Memorandum

To: Chula Vista Energy Upgrade Project (07-AFC-4) file

Subject: **CHULA VISTA ENERGY UPGRADE PROJECT (07-AFC-4) PUBLIC COMMENTS ON PSA FROM THERESA ACERRO, SOUTHWEST CHULA VISTA CIVIC ASSOCIATION**

MegaWatts Per Square Mile and Percent NonWhite Population, Natural Gas & Landfill Gas Facilities Only

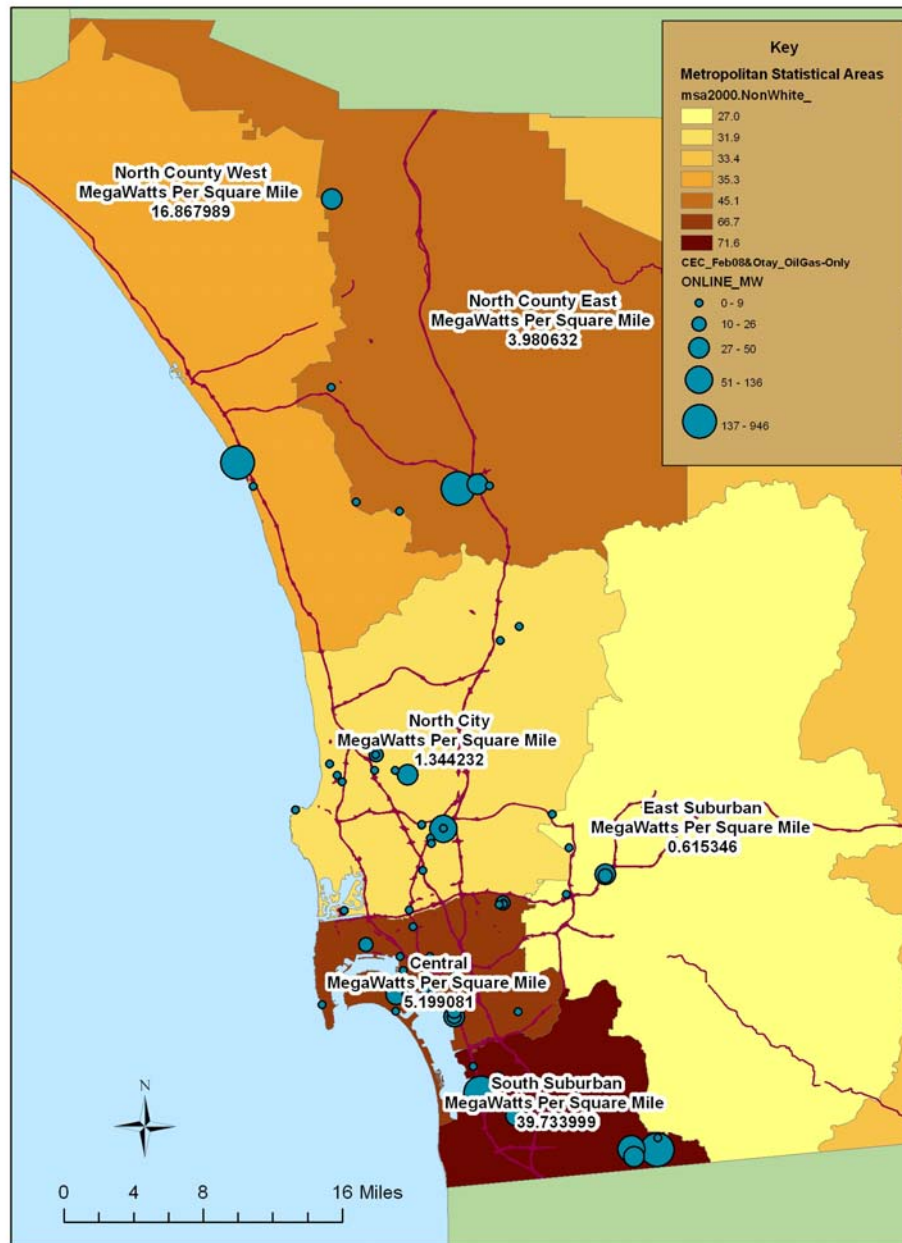
SDG&E has said that there is no need for peaking power in the southbay as the map below shows. ISO has said the the RMR status of the SBPP will not be removed unless Otay Mesa comes on line and either two peakers further north or The Sunrise Powerlink come on line. In any case it will not close before 2010. CVEUP has no relationship to closing SBPP. This statement needs to be removed from the FSA. Therefore, staff's conclusions are not correct and need to be rewritten for the FSA.

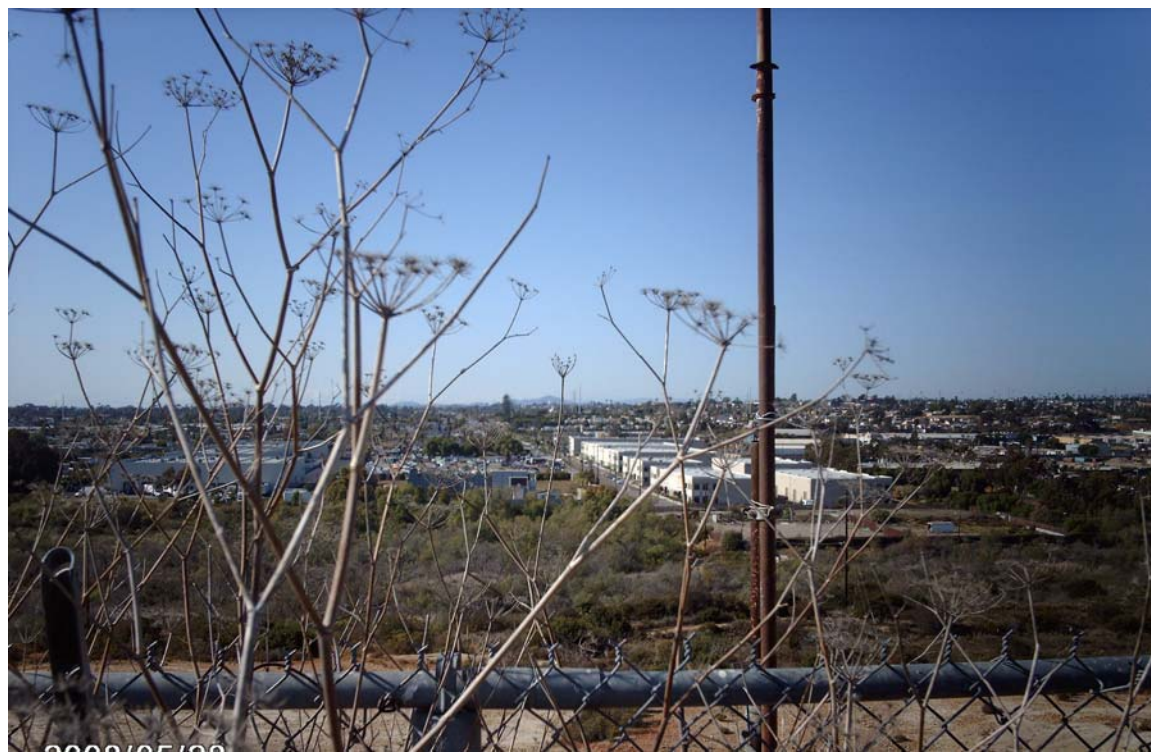
This was shot from the corner of Banner and Main. More of the towers will likely be visible than what is portrayed in MMC's visual. The impact will be negative for these businesses, giving the impression of heavy industry. There is no auto recycling yard across the street. Esparza tires sells

tires and does auto repairs. In one easy step this building will go from upscale to harboring something dangerous to the public by sprouting two smoke stacks. Again since water is used in the cooling process there

will be steam that causes a visible plume that we will correctly interpret as spreading contamination and something to avoid.
